BUILDING SCOPE ADDENDUM NO. 01

This Addendum is a summary of clarifications, interpretations, corrections and/or modifications to the Contract Documents for the Conestoga High School Athletic Fields Project prepared by Heckendorn Shiles Architects.

1 S100 FIELD HOUSE FOUNDATION PLAN

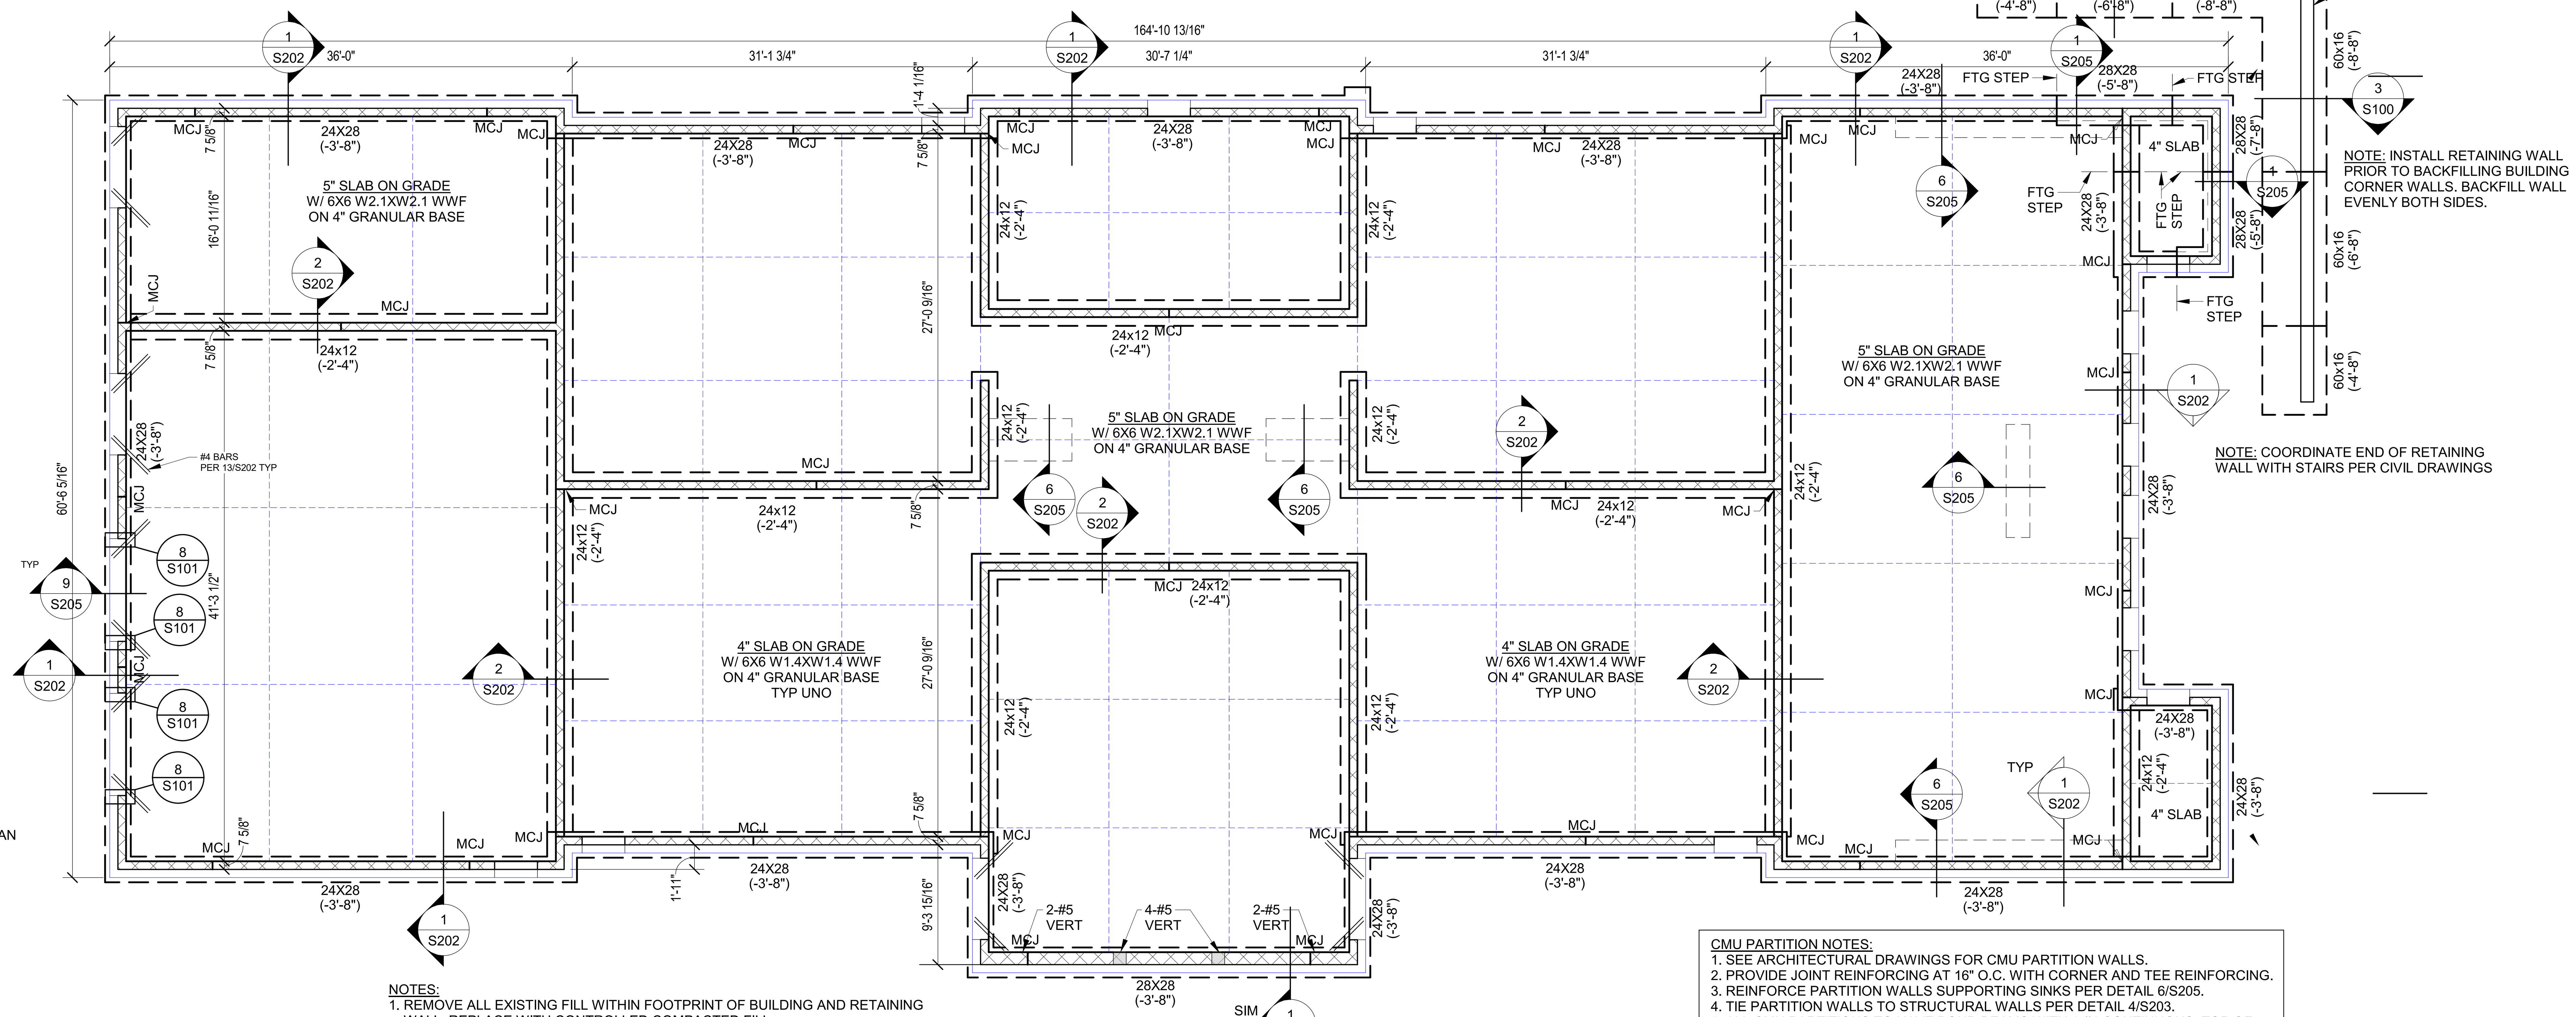
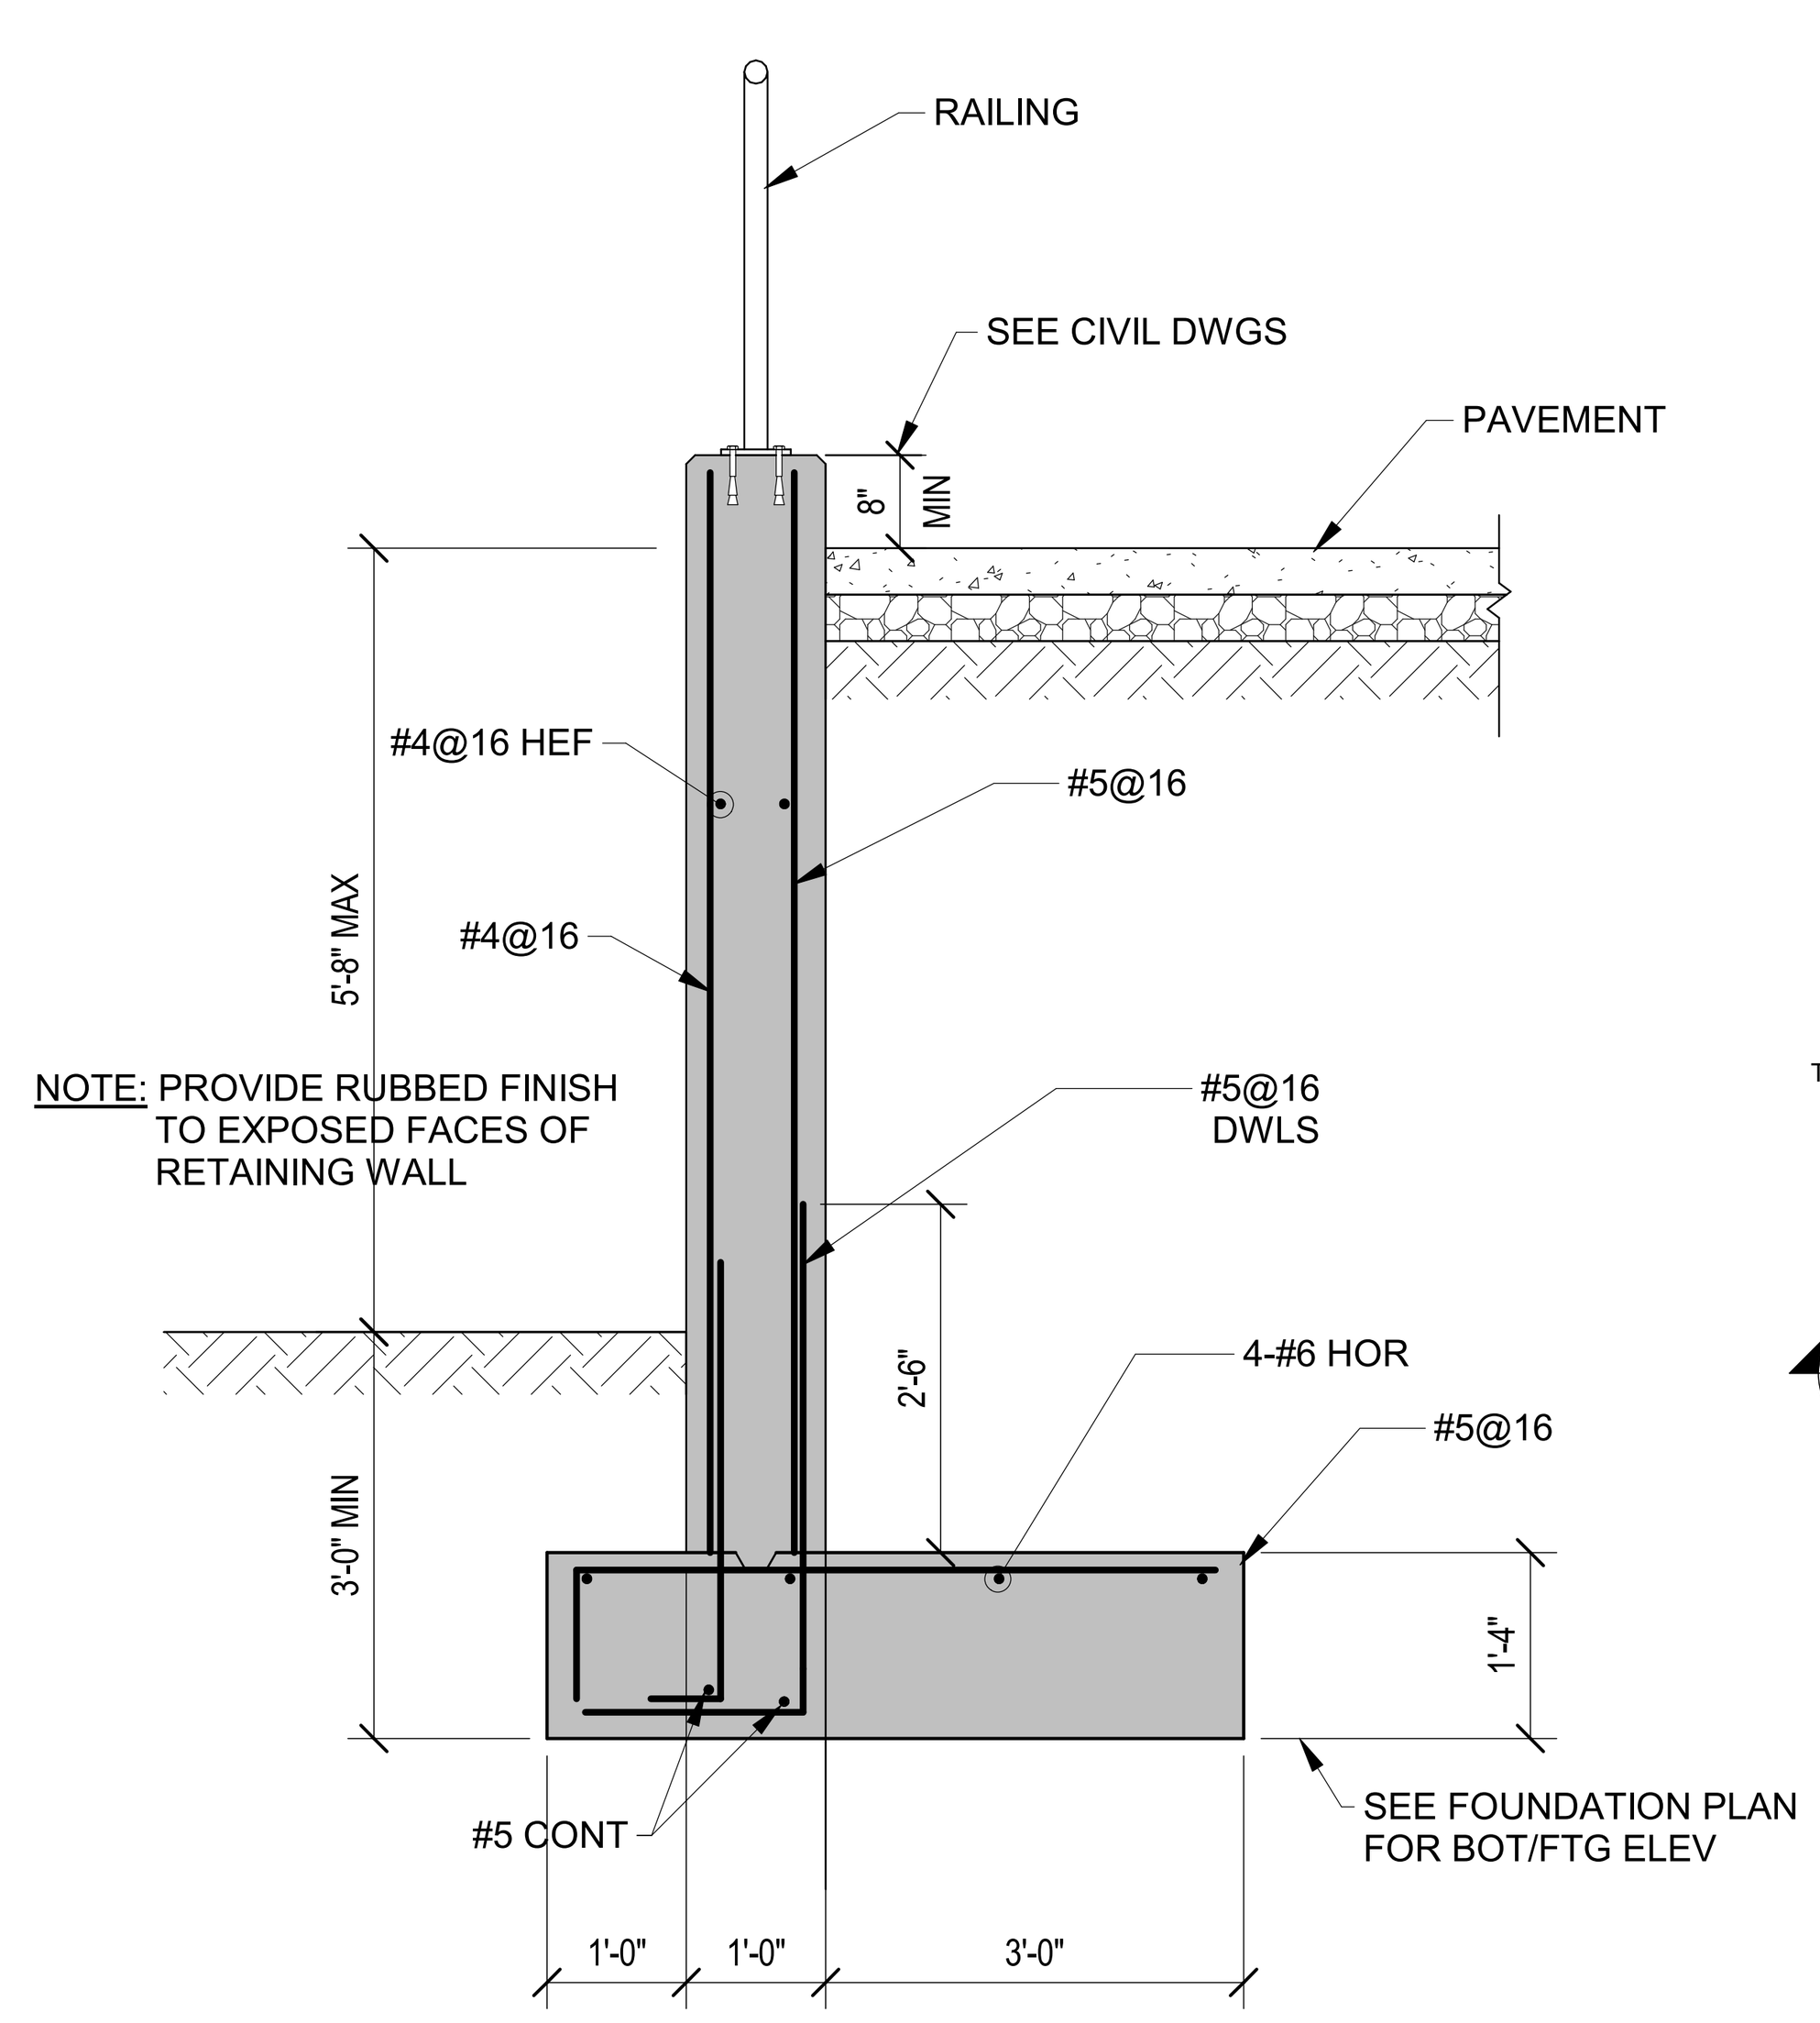
1. Drawing – S100 Updated steel support in restroom.

1 M102 GROUNDS
1/4" = 1'-0"

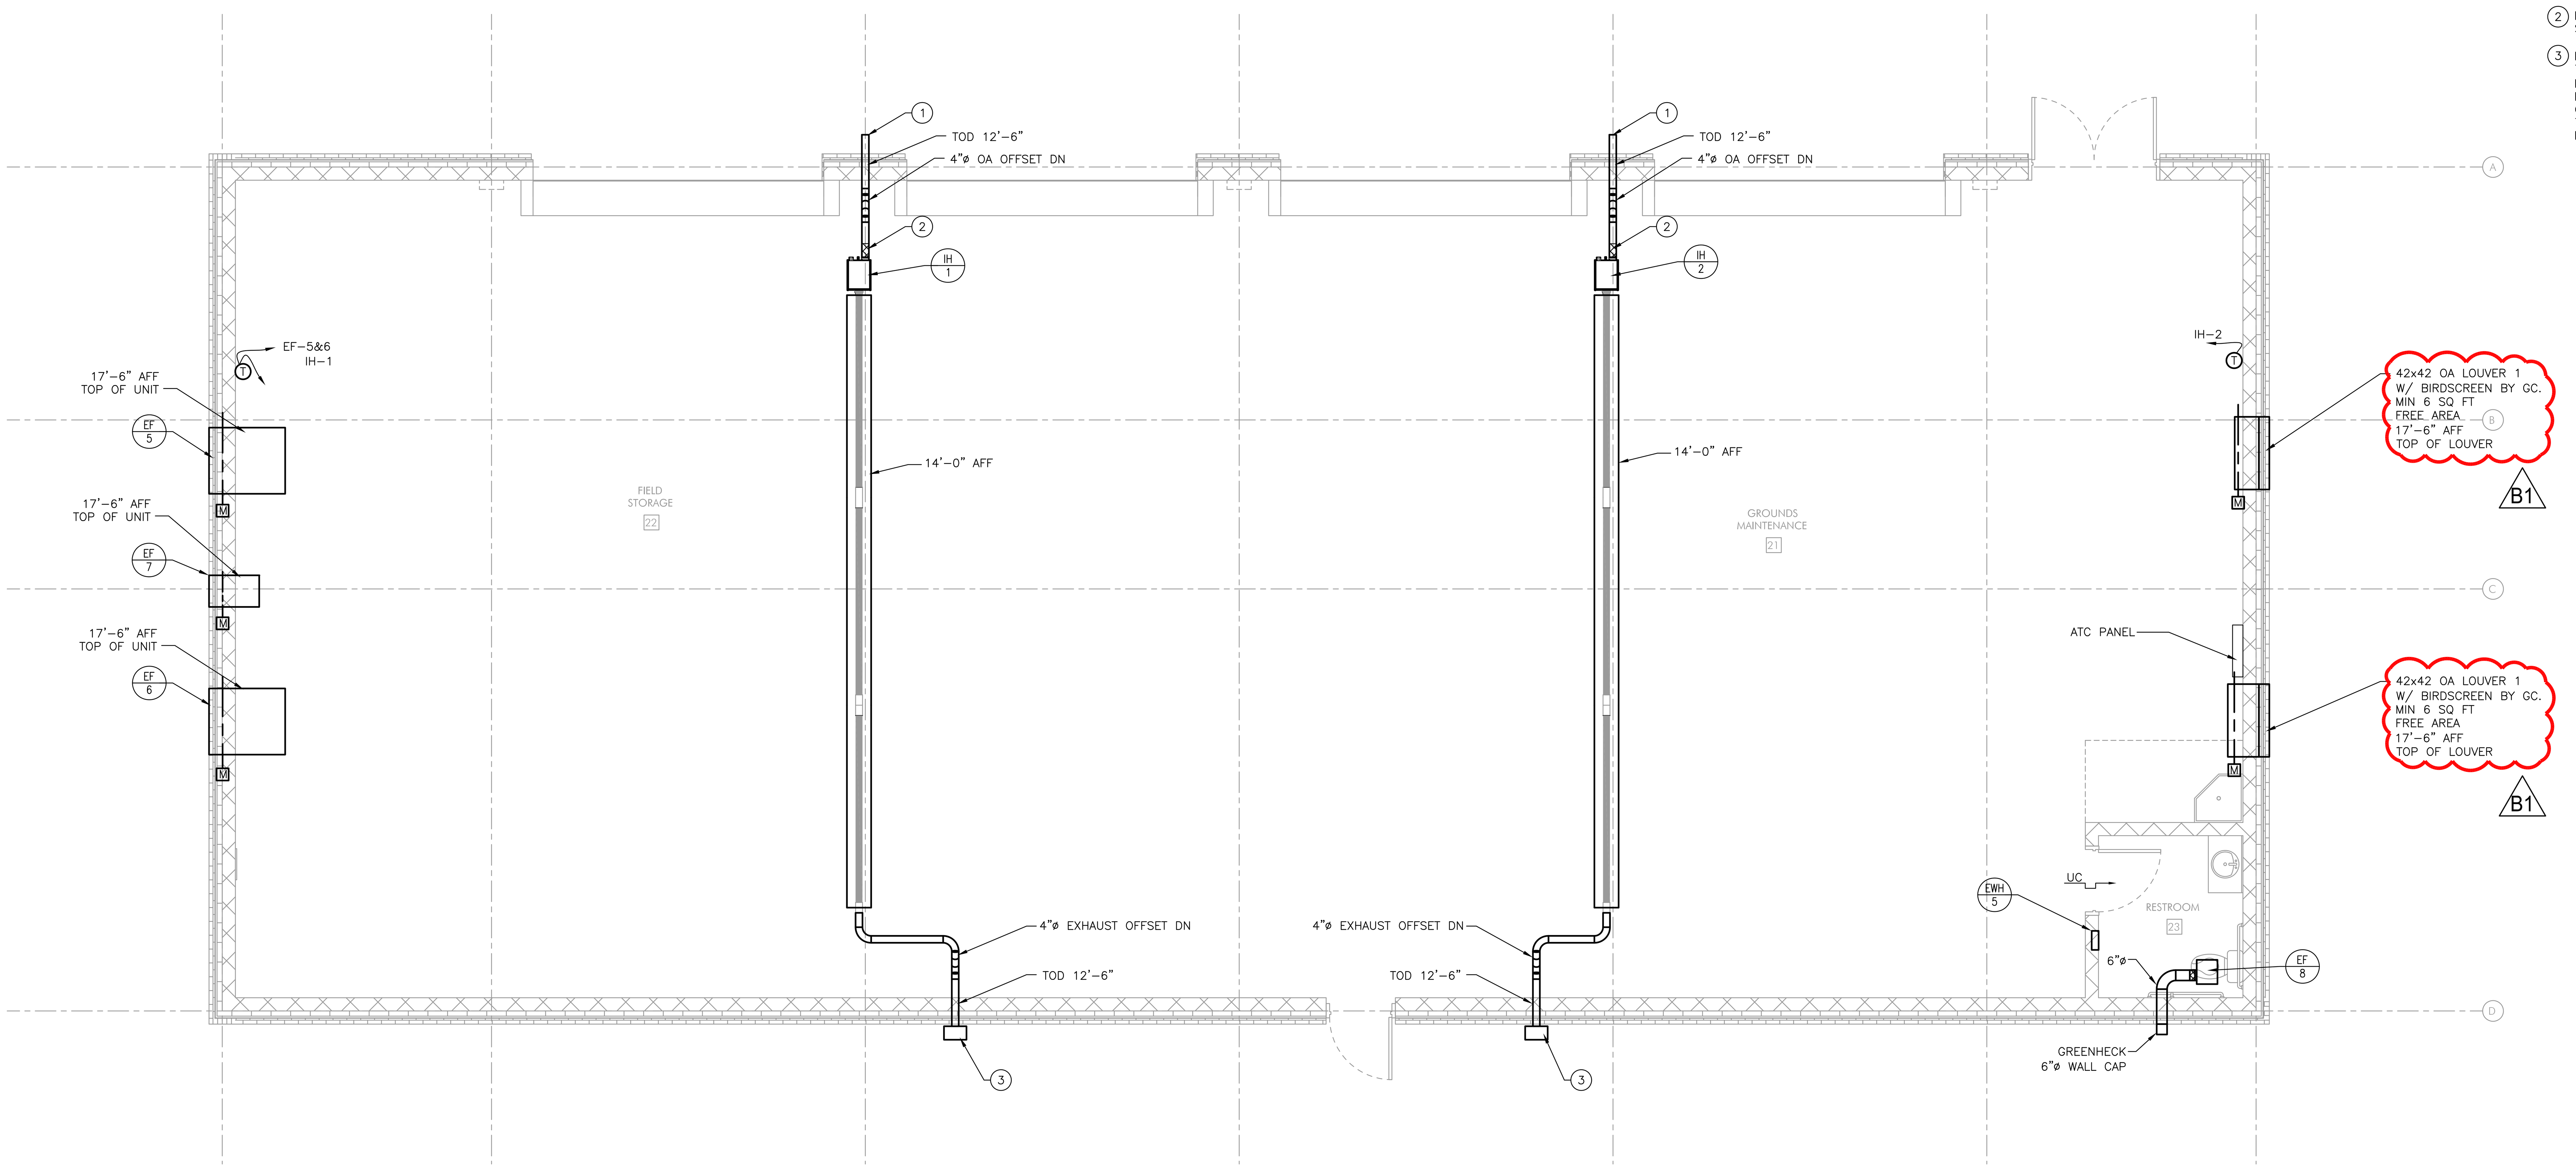
1. Drawing – M102 Clarified louver description
